Liberty School District – Technology Remodel
Addendum No: 001
Description Narrative
October 23, 2023

Revised Architectural Sheets: AS101.
Refer to Smith & Boucher, MEP Addendum No. 1

A1 SHEET AS101 – ARCHITECTURAL SITE PLAN - OVERALL

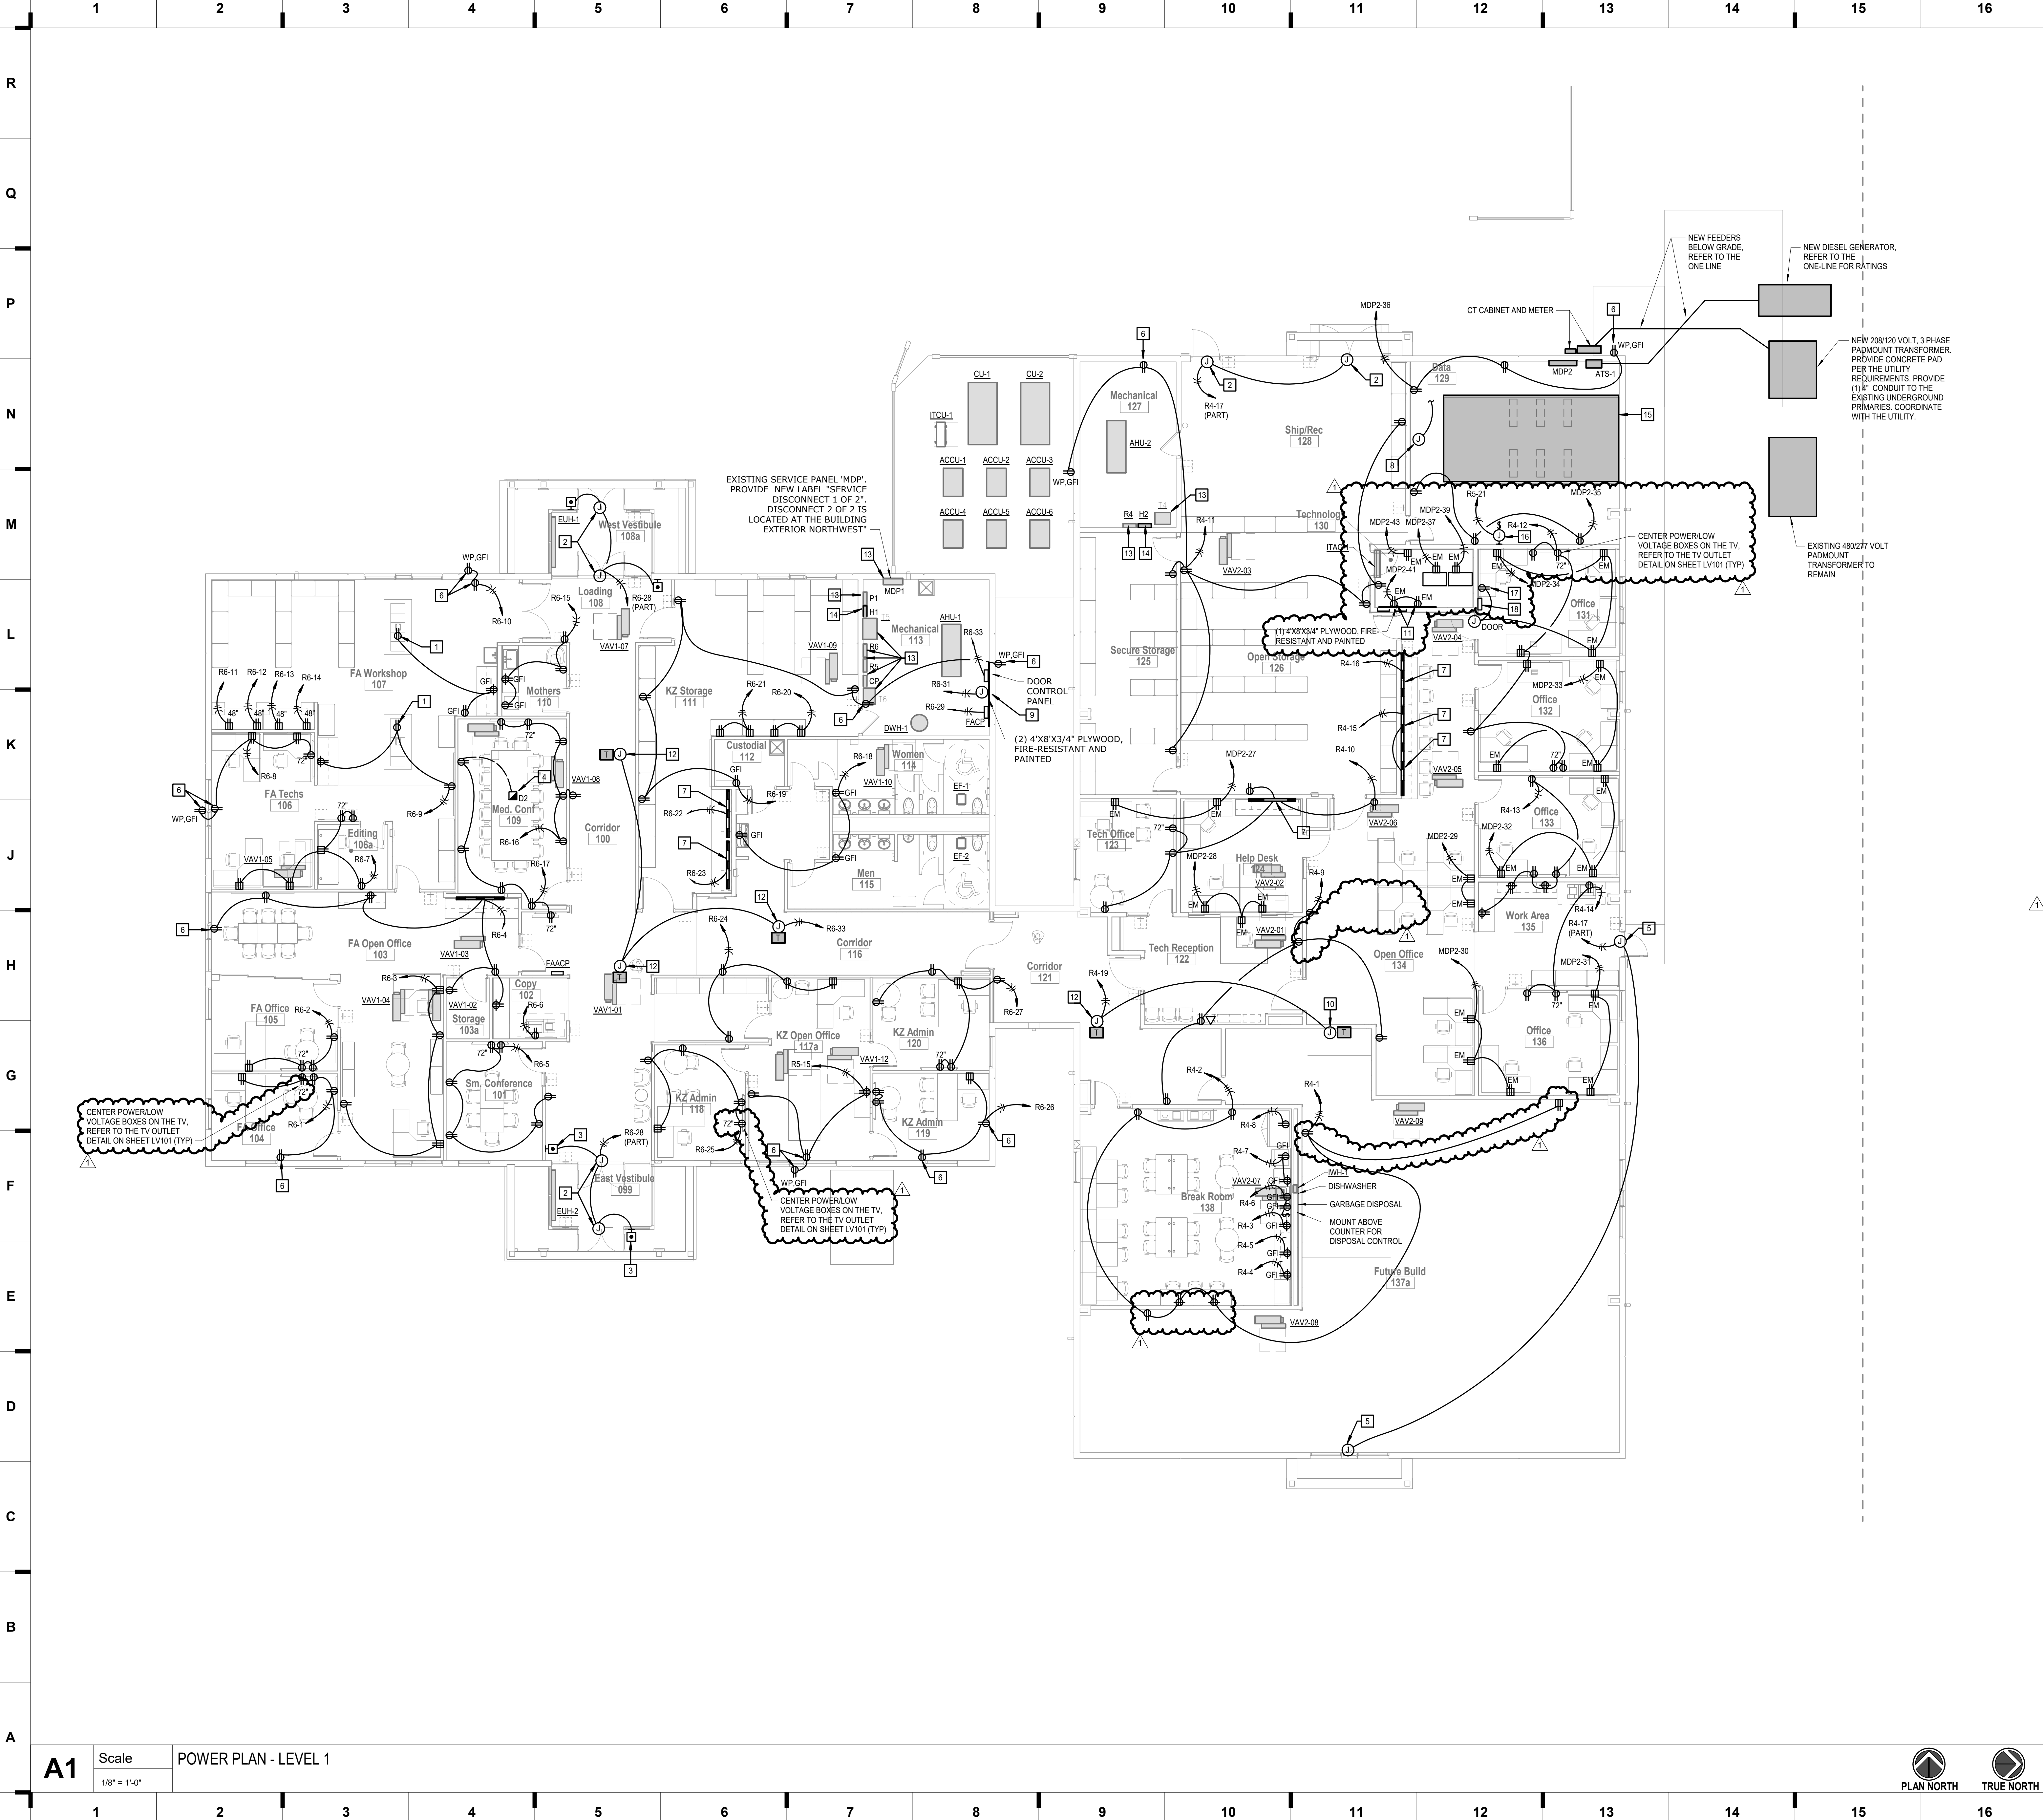
A1.1 REPLACE Sheet AS101, with attached Sheet AS101, dated 10/20/2023. ADDED view D1 to clarify existing fiber line locations.

ES101

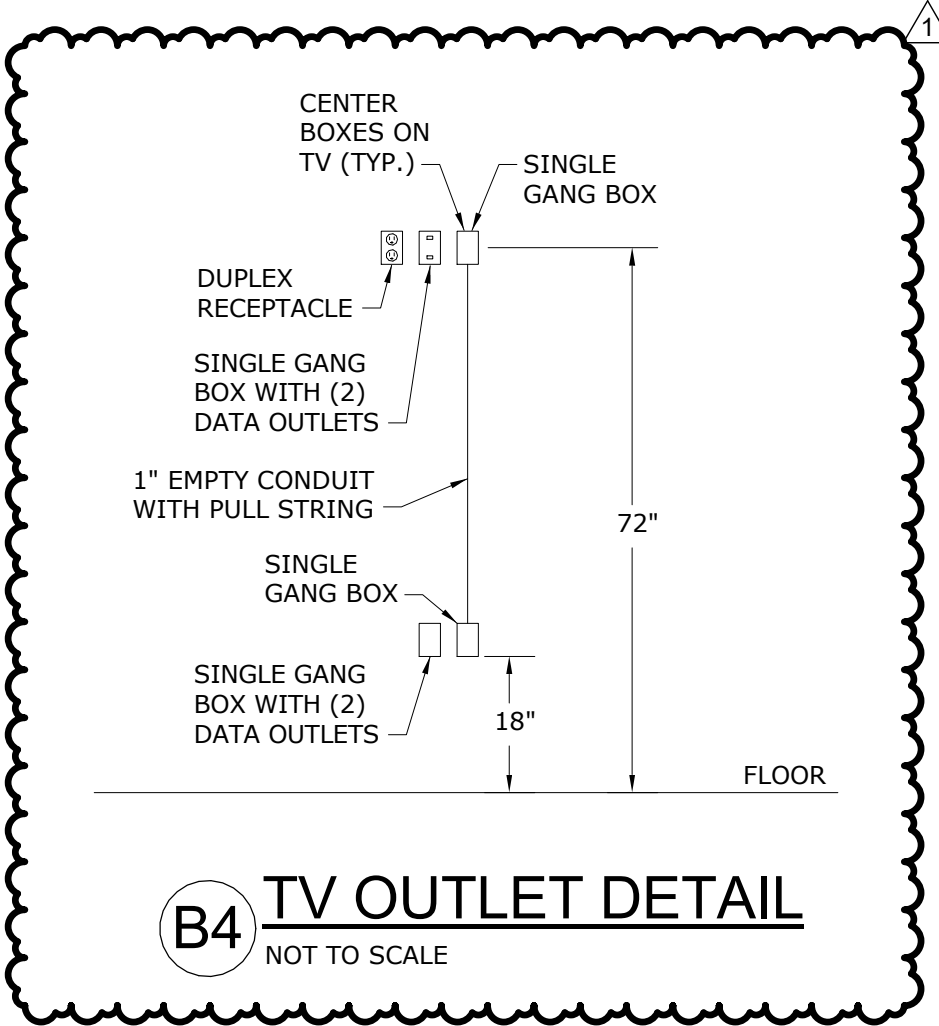
3. Sheet ES101 – ELECTRONIC SECURITY PLAN – LEVEL 1
 - a. Door lock connection and card reader removed at the door to Sm Conference 101.
 - b. Door lock connection and card reader added at the door to FA Open Office 103.

A1 Scale TELECOMMUNICATIONS PLAN - LEVEL 1

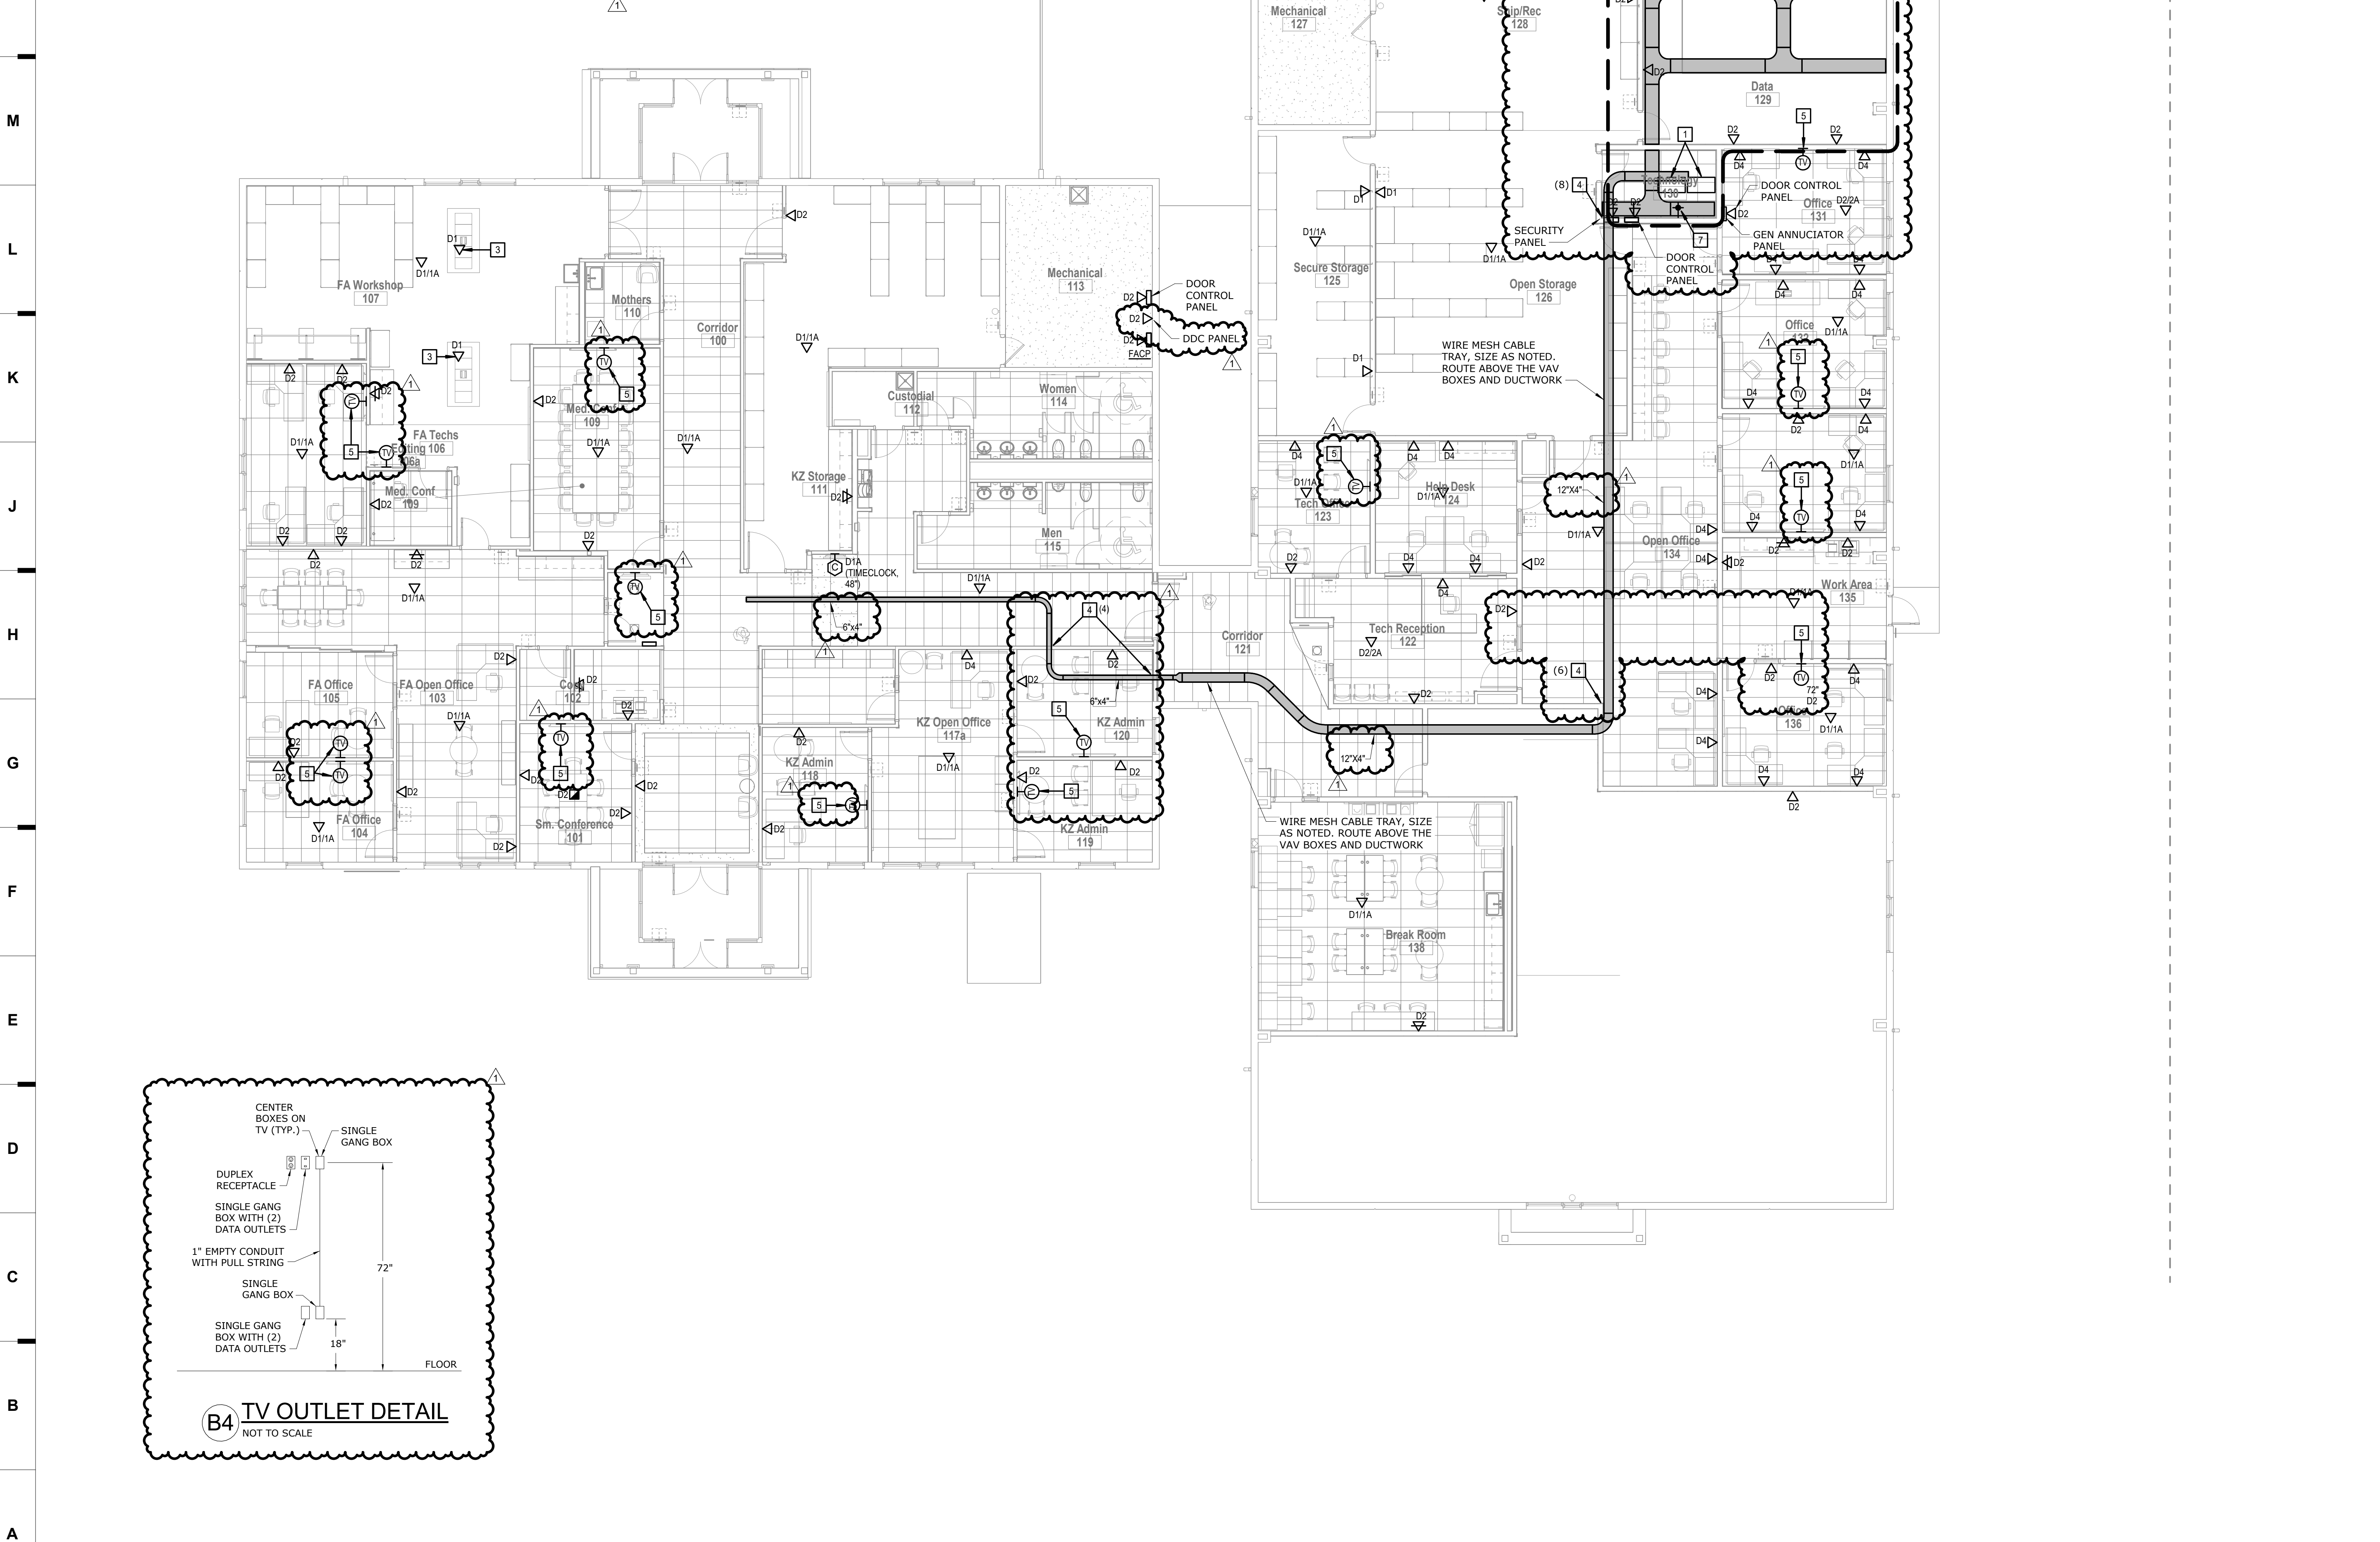
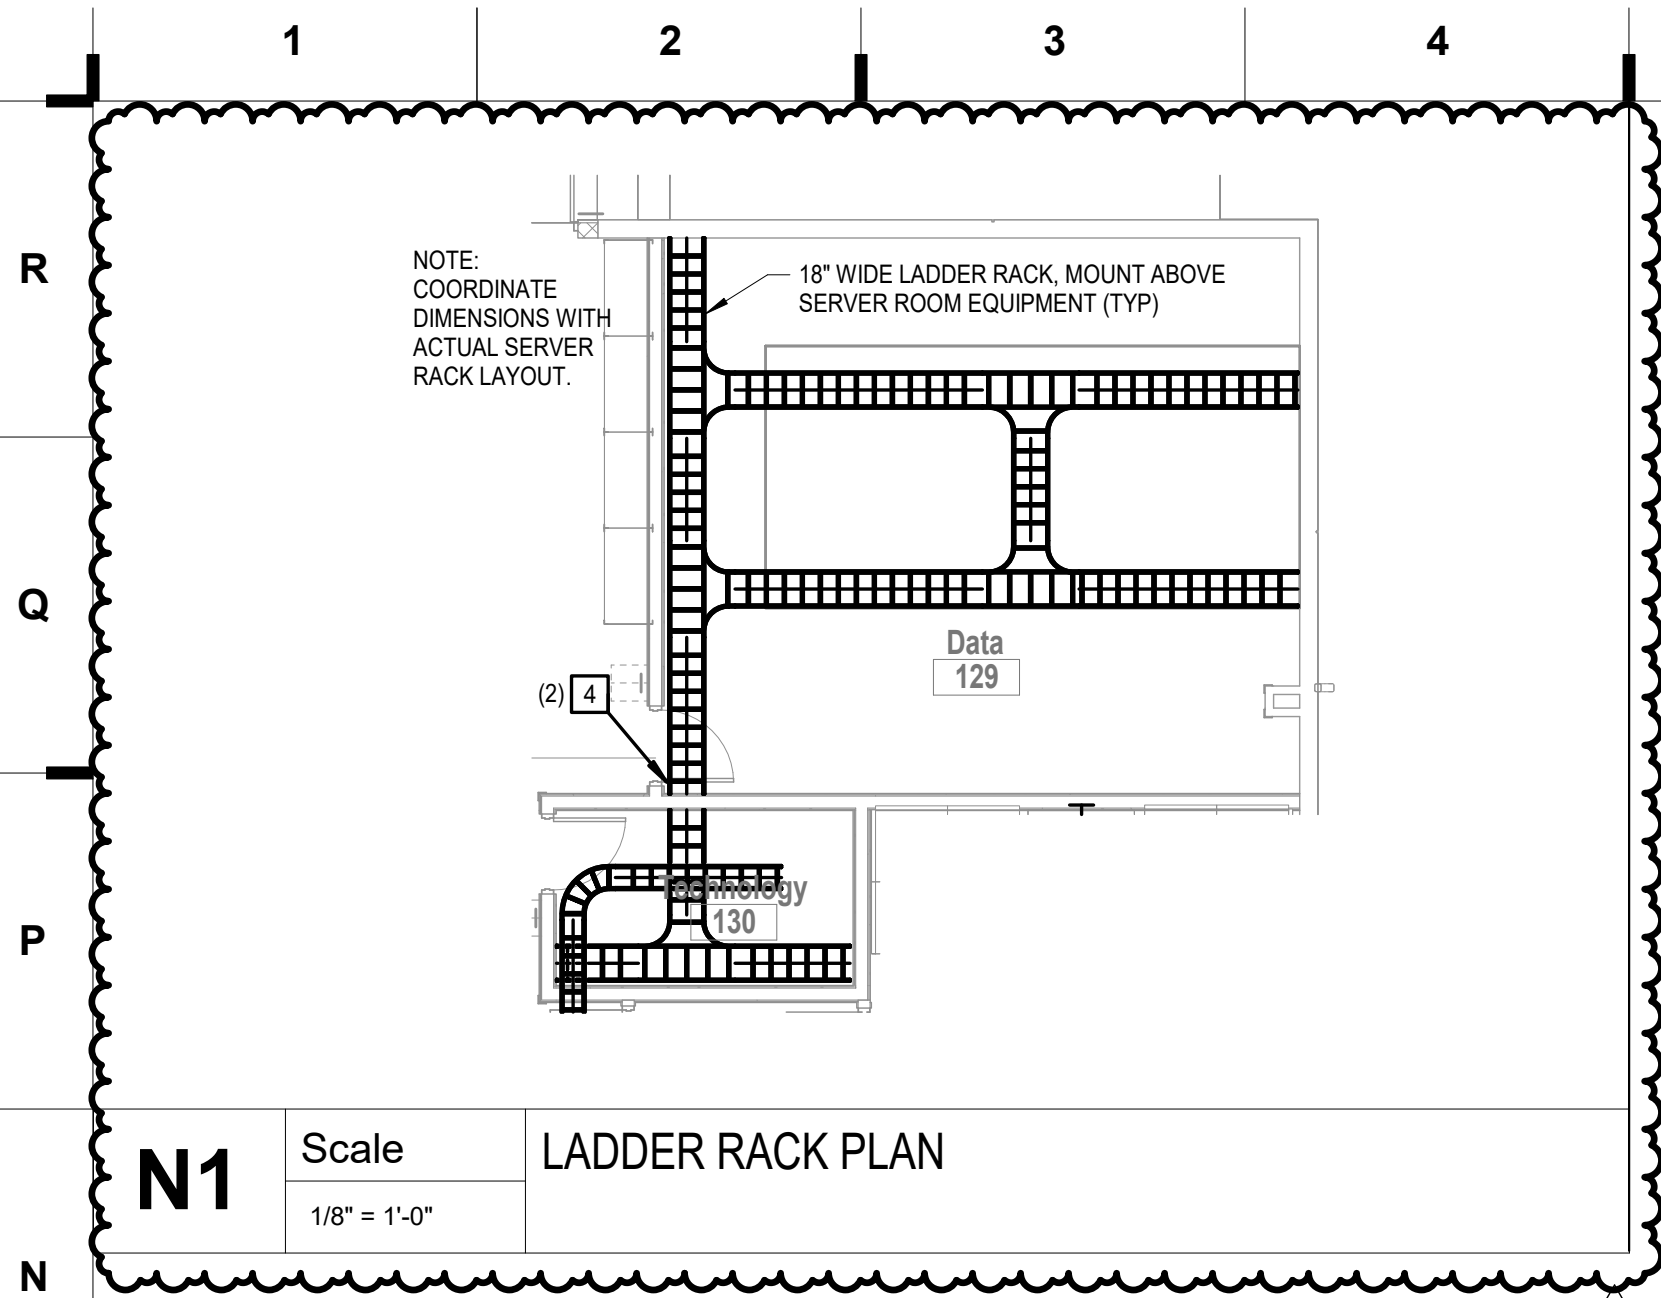
4. Sheet LV101 – TELECOMMUNICATIONS PLAN – LEVEL 1
 - a. Door lock connection and card reader removed
 - b. TV Outlet Detail added, plan note references added to the TV locations.
